Final Drainage Report

Double Spur Ranch Minor Subdivision 12420 Meridian Rd, Colorado Springs, CO 80908

Unresolved from review 1: Add PCD File No. MS-235

SUMMARY - EXISTING RUNOFF TABLE					
DESIGN POINT	BASIN DESIGNATION	BASIN AREA (ACRES)	DIRECT 5-YR RUNOFF (CFS)	DIRECT 100-YR RUNOFF (CFS)	
1	А	110.43	23.84	160.20	
2	В	13.48	4.29	26.46	
TOTAL		123.90	28.13	186.66

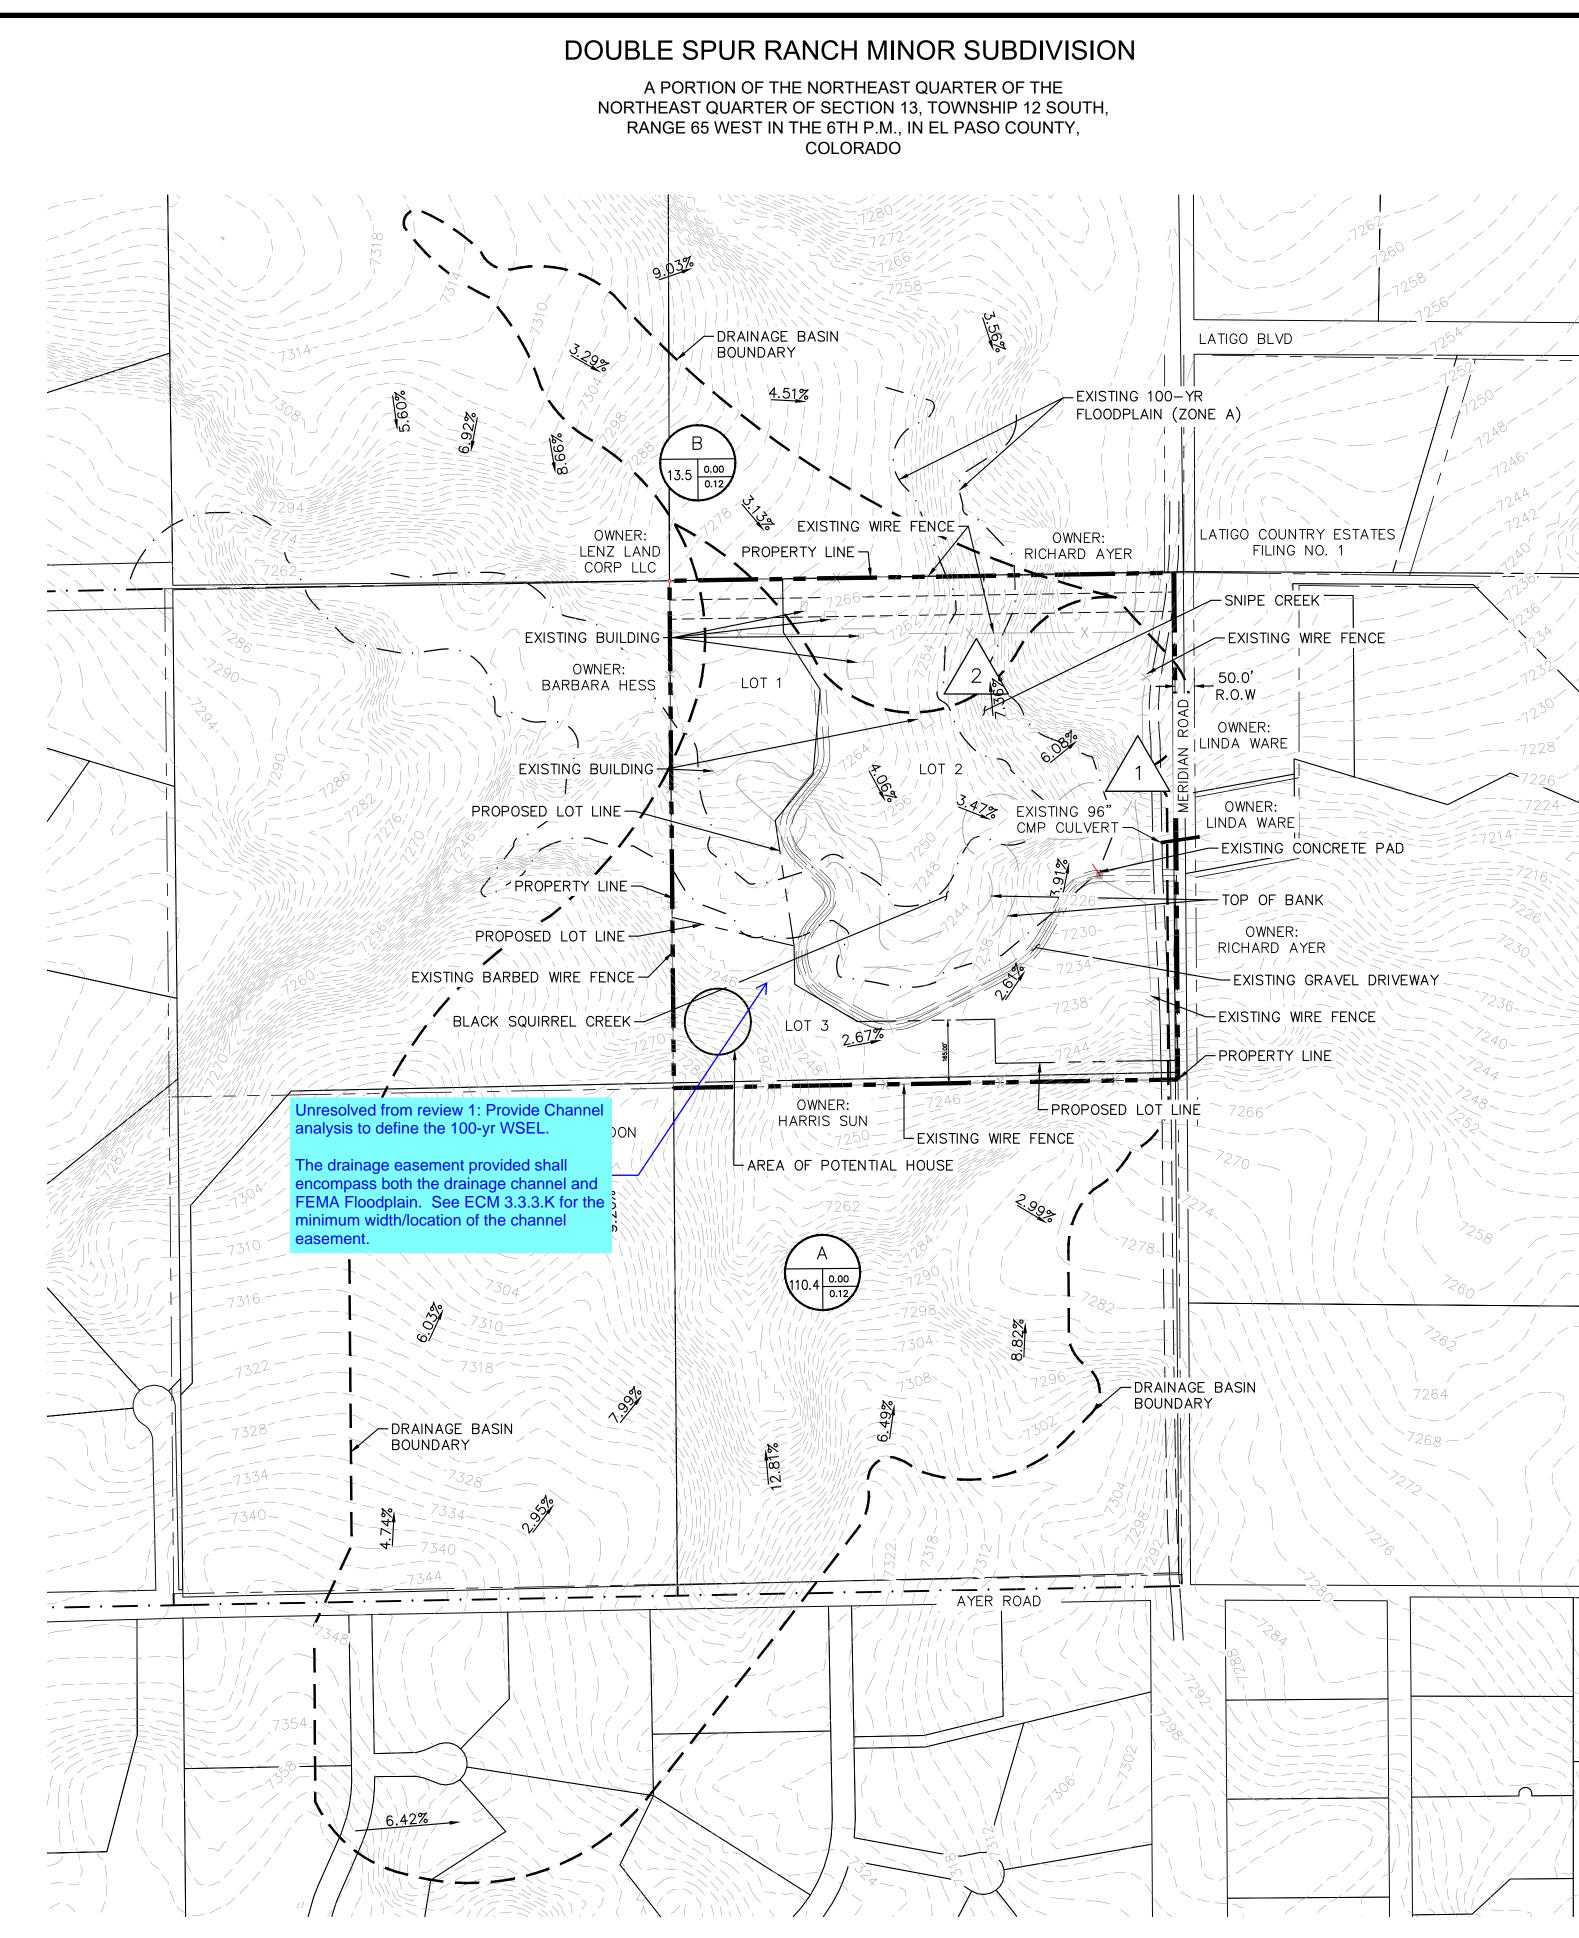
Unresolved from review 1: Provide proposed runoff values in a summary table.
